**SEAS DEADLINE 6 RESPONSE to APPLICANTS's SUBMISSIONS**  
**SINCE DEADLINE 5, ISH3, Action Points and ExQ3**  
**LANDSCAPE & VISUAL and CULTURAL HERITAGE**

**PINS Ref:** EN020026  
**DEADLINE 6:** APRIL 13, 2026

# EN020026 SEA LINK DCO – DL6: RESPONSE BY NICHOLAS BRIDGES

## ZTV ANALYSIS – IP ref FA62B0DA

**Figure 7. Sea Link 2023-10 PEIR Volume 3 Part 2 Chapter 2 Figures A, page 9:**  
 REPRESENTATIVE VIEWPOINT LOCATIONS AND SCREENED ZONE OF THEORETICAL VISIBILITY - PROPOSED SAXMUNDHAM CONVERTER STATION AND SPR FRISTON SUBSTATION (OPTION 2)

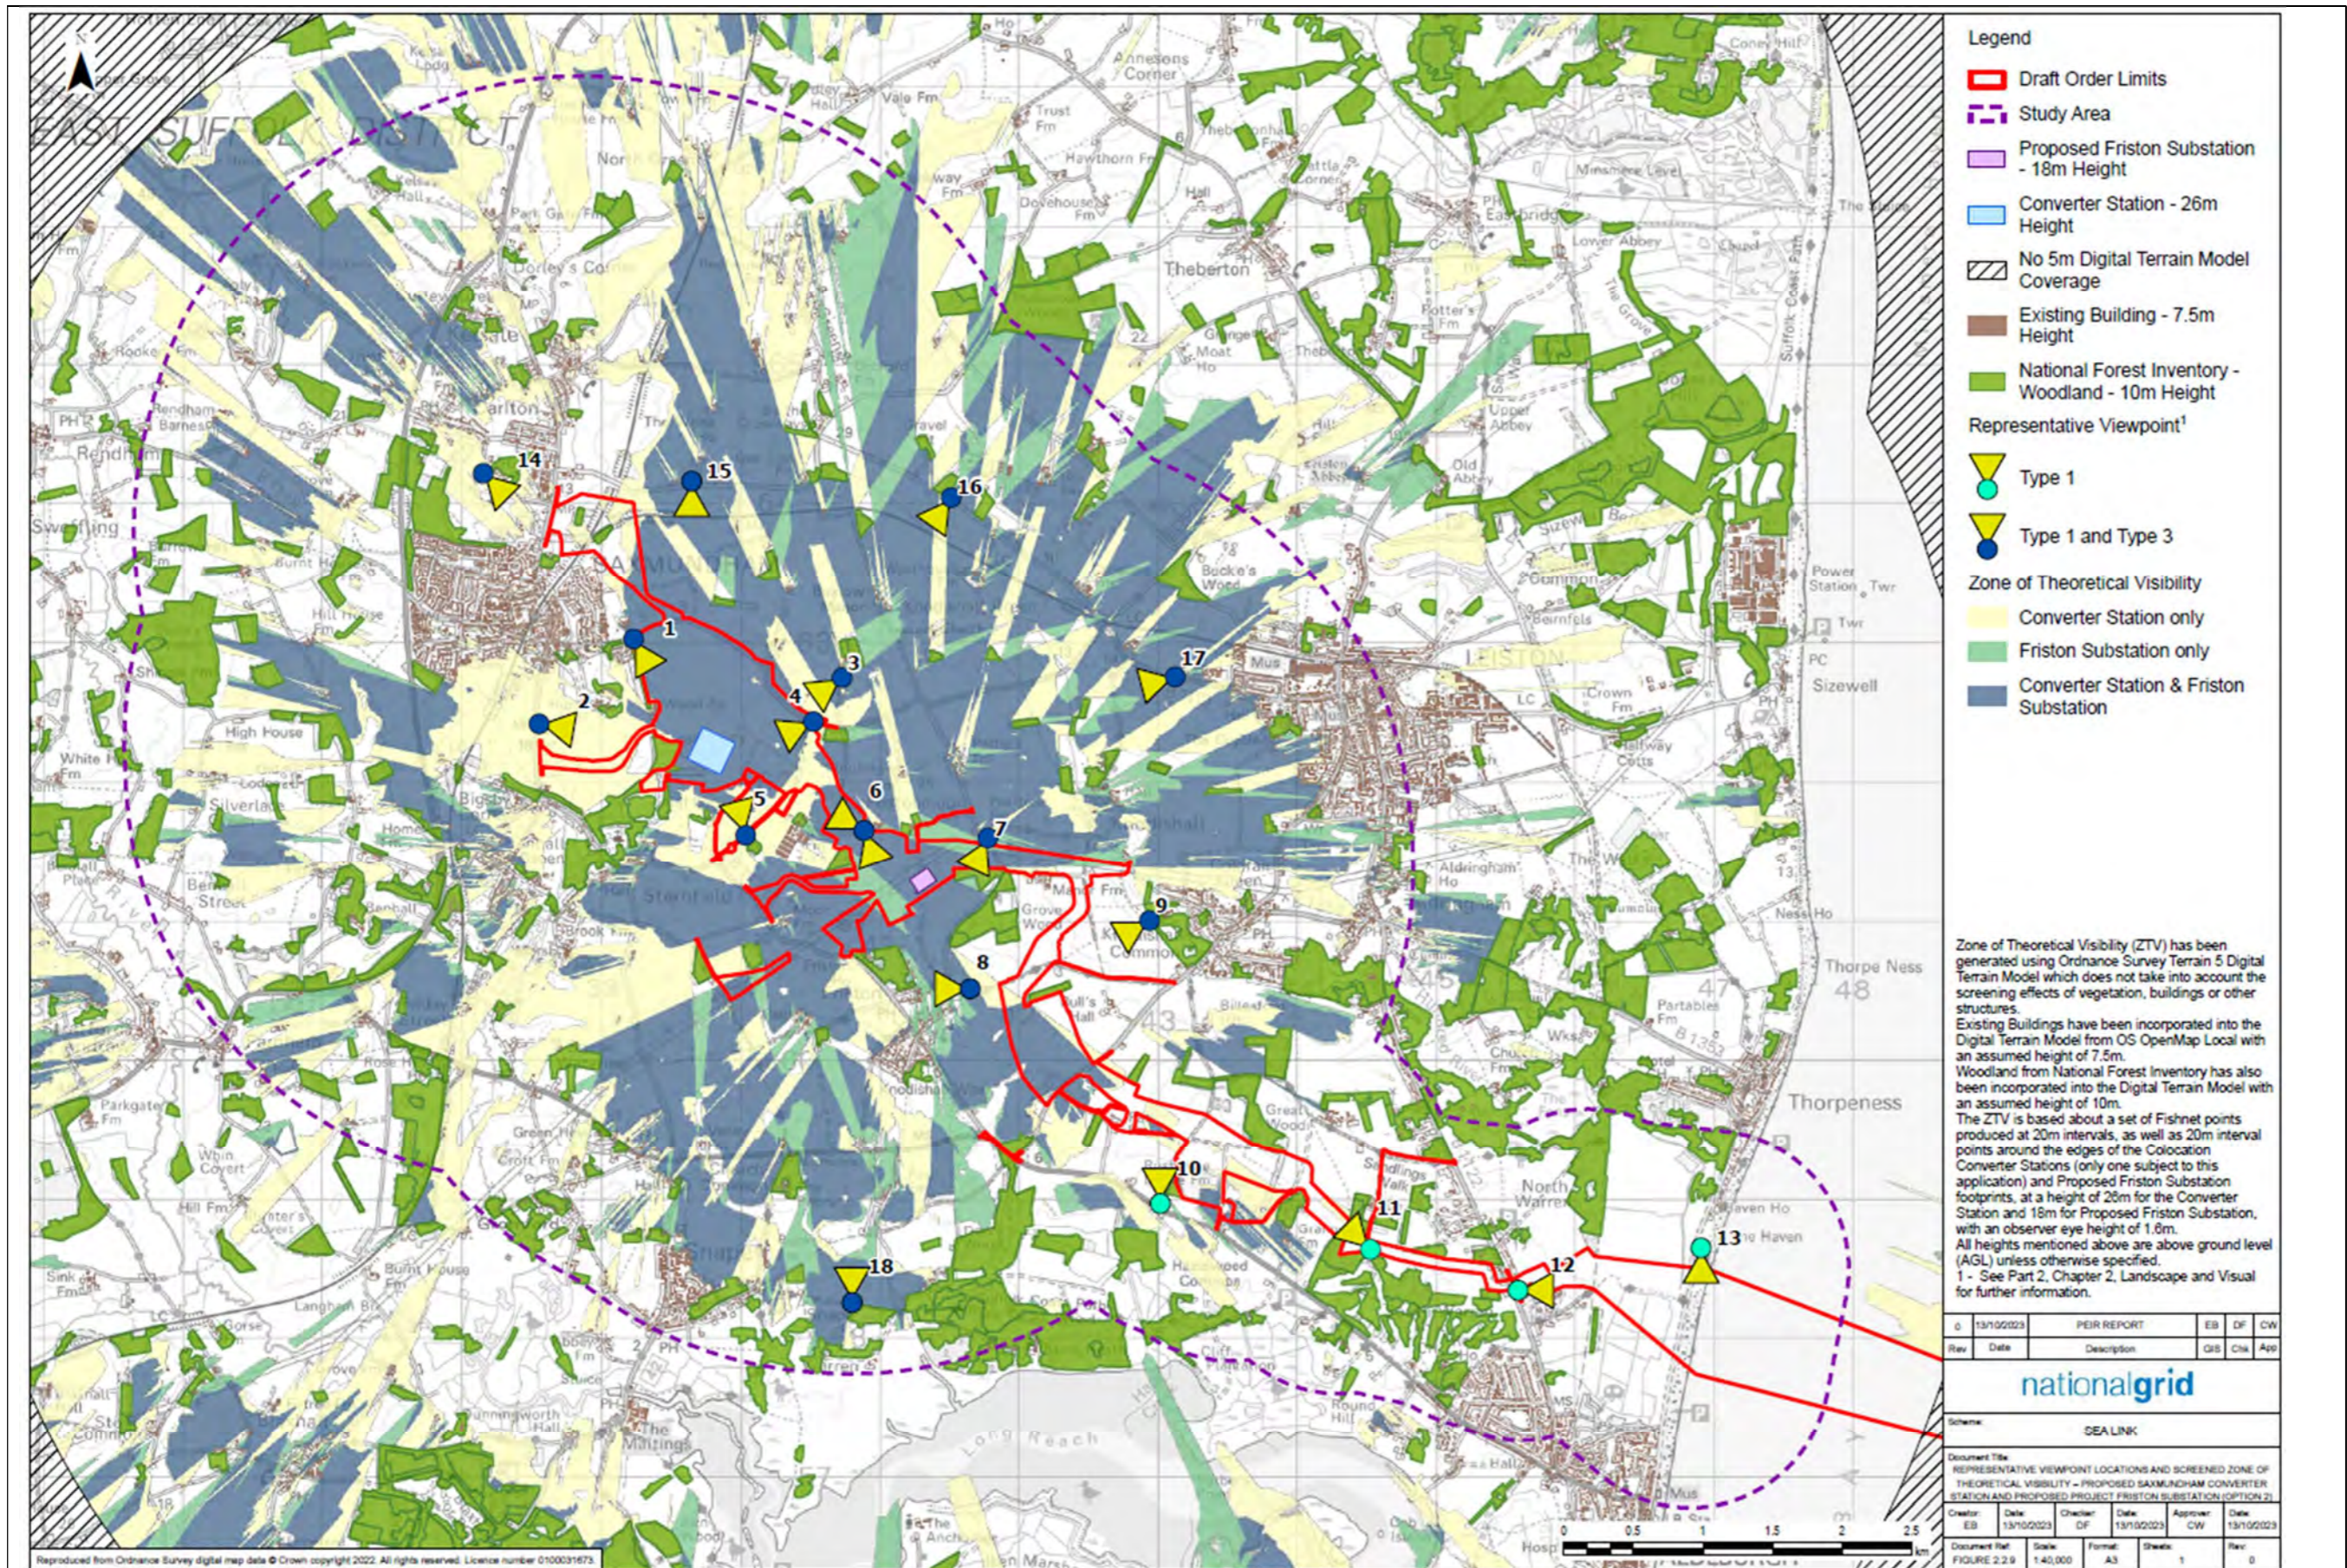
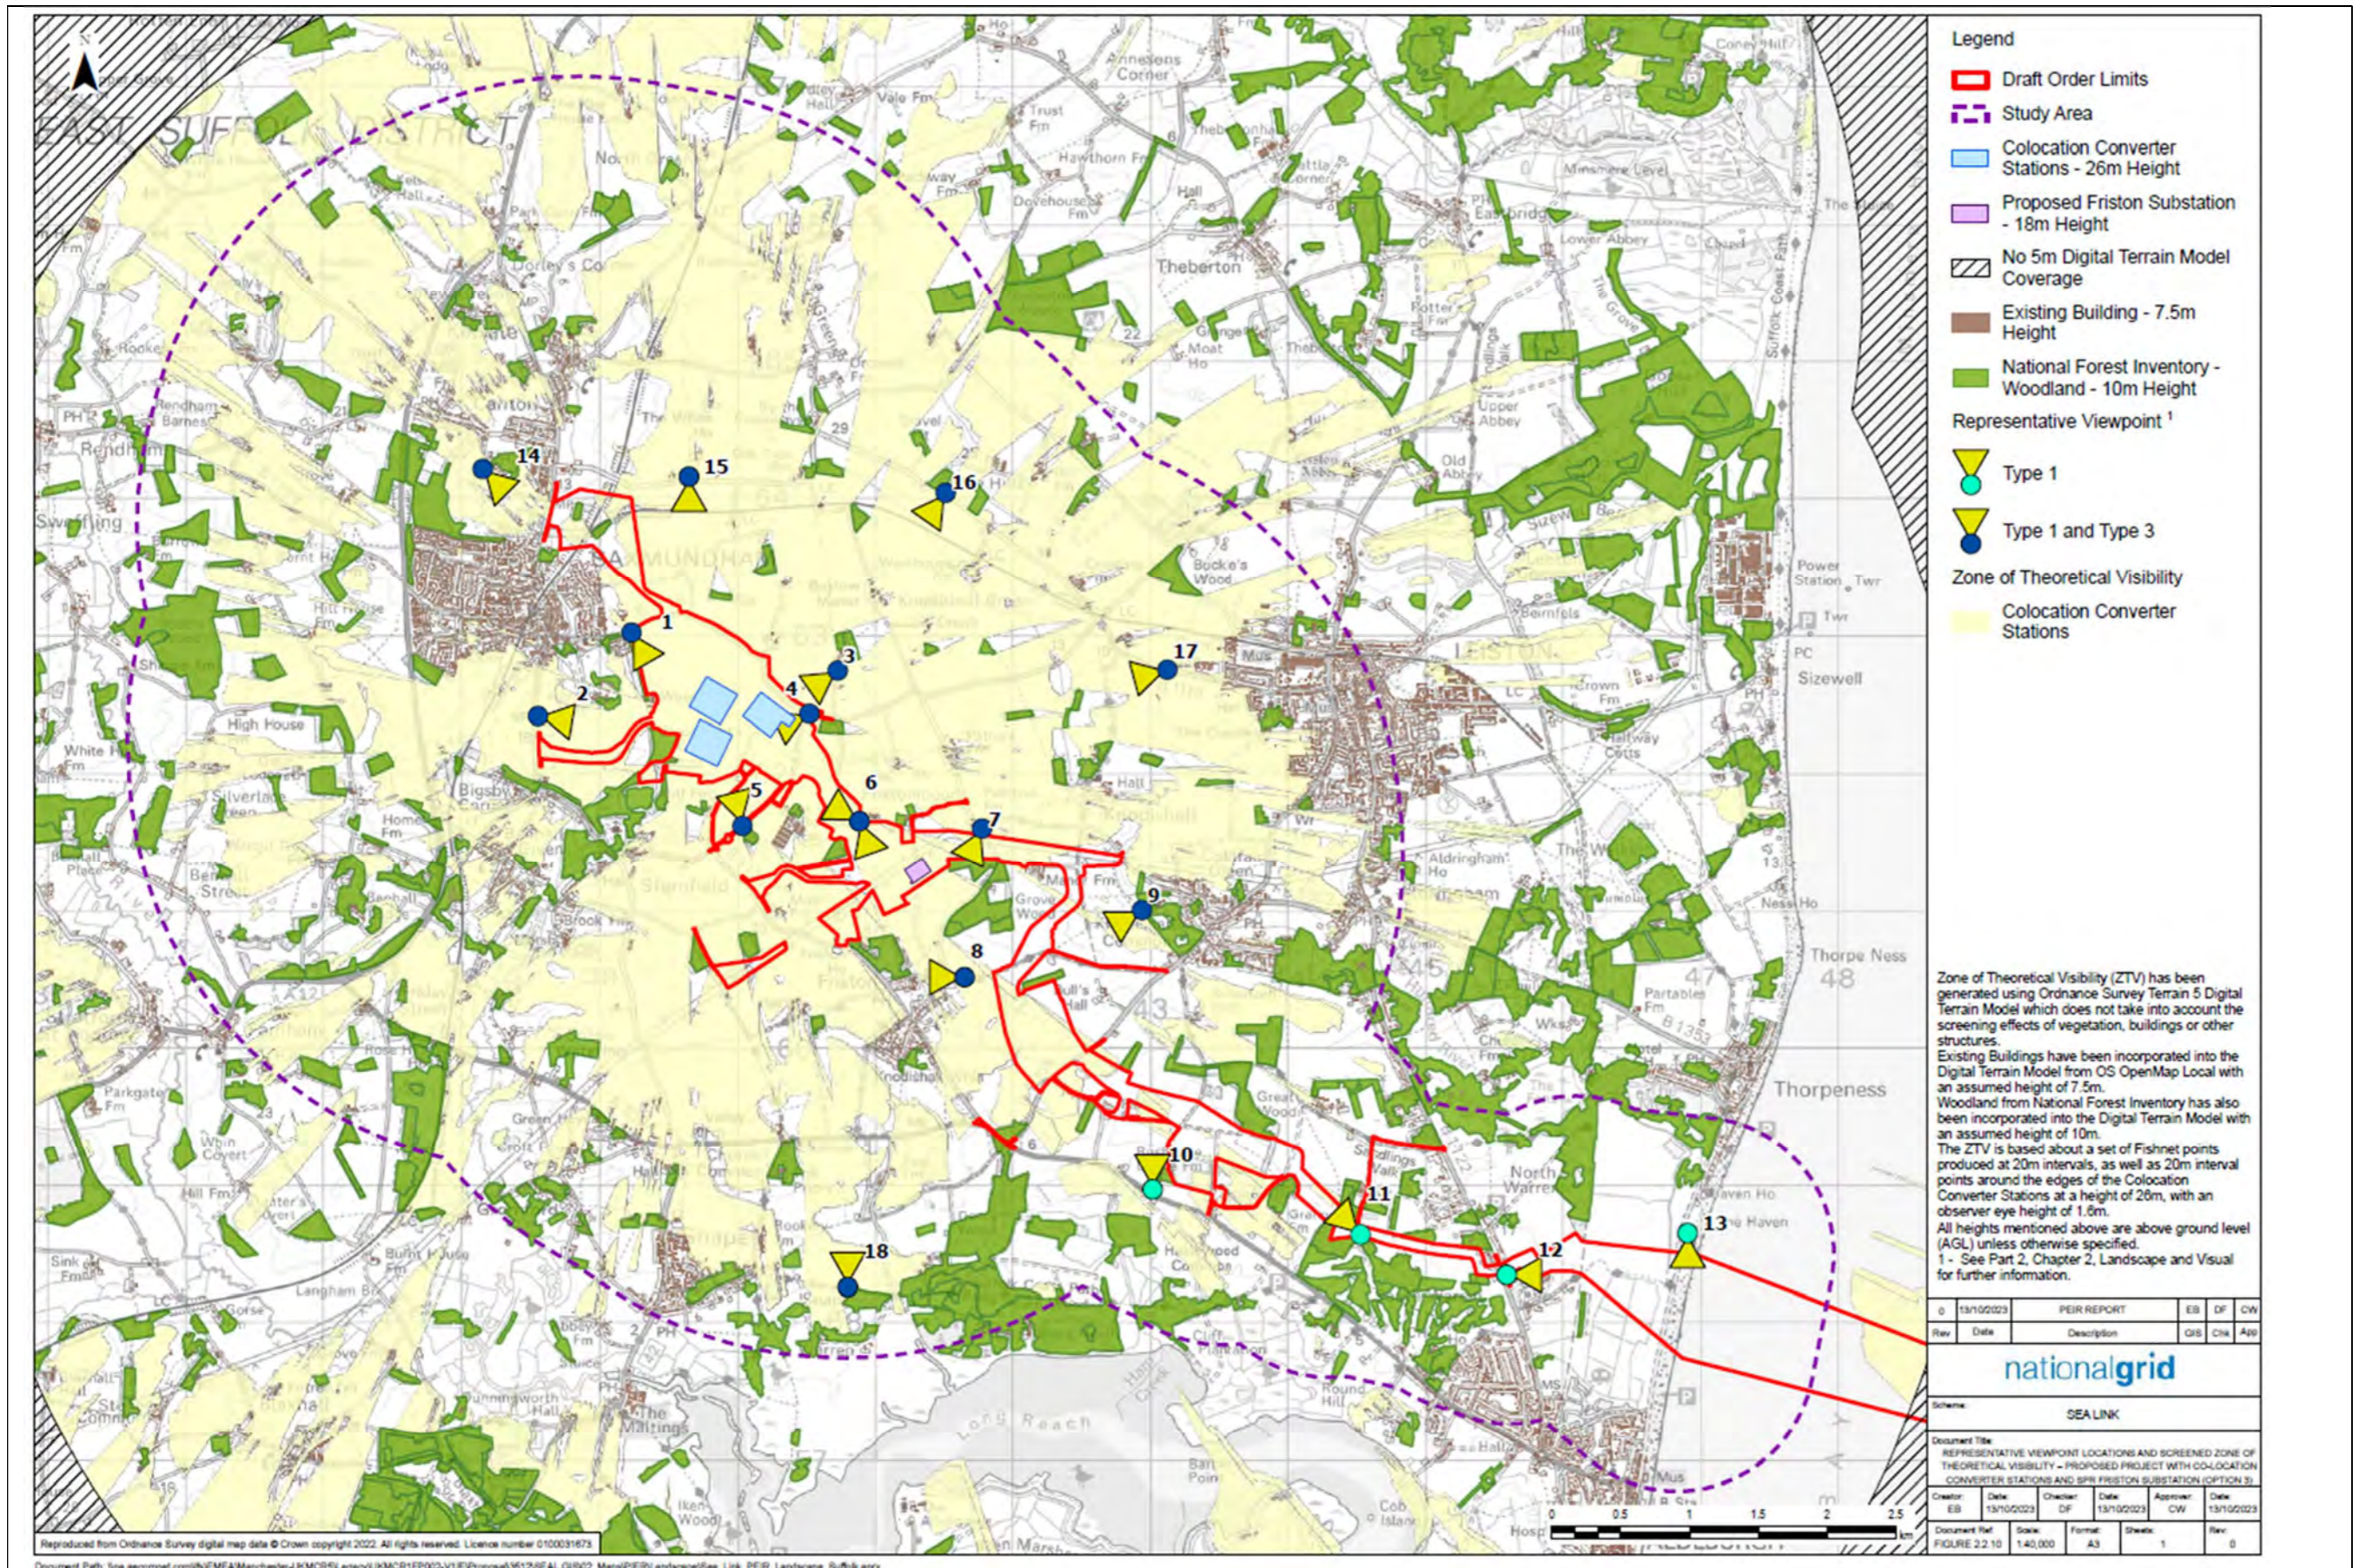
2.9. The ZTVs of the two Friston projects and Sea Link's PEIR have a similar pattern of visibility around their projects (see **Figures 1 to 11** below). Sea Link includes the National Grid substation at Friston which each of EA1N and EA2 also included. All Projects were modelled using OS contours, woodland and buildings at a generic height. Observer heights were a little higher for EA1N and EA2. The two Friston substations used the same parameter model as Sea Link.

2.11. The **first question** is: why are the PEIR and DCO plans so completely different? Were the heights in the model changed? Were the shadowing criteria altered? Which is correct? If the DCO is correct, were the EA1N and EA2 ZTVs incorrect? These are simple technical points which can be explained easily.

2.12. The **second question** is: With the majority of the ZTV plans showing extensive visibility of both Friston substations (18m above ground level) and Sea Link (26m above ground level) on the south side of the Alde estuary, at high tide mark and on the 20m ridge above, why was the information on these plans not followed or commented upon?
